# INITIAL FIRE SAFETY INSPECTION REPORT

**Shanta Denims Limited (Extension)**

**RSC ID: 25929**

# Fire Safety Inspection Report

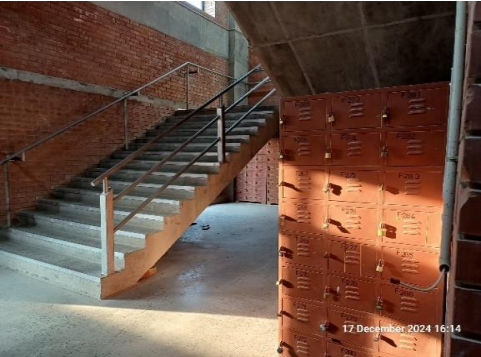
F-10	Means of Egress	<p>The exit stair enclosures are not properly separated from work areas and other spaces on each floor due to partially non-functional fire doors and unprotected opening from lift machine room of New Production Building (Building-6).</p>	<p>The exit stair enclosure shall be provided with a minimum 2-hr fire resistance rating for buildings with 4 or more stories. Provide 1.5 hr. fire rated door and seal all penetrations and openings by 2hr. fire rated fire rated barrier construction for building with 4 or more stories (vestibules to separate any storage areas).</p> <p>Ensure that the fire doors are self-closing and positive latching and that they are provided with fire exit (panic) hardware where serving production floors. If fire doors are required to be held open for functional reasons, provide automatic closing devices tied to the fire alarm system.</p>	Within 3 months
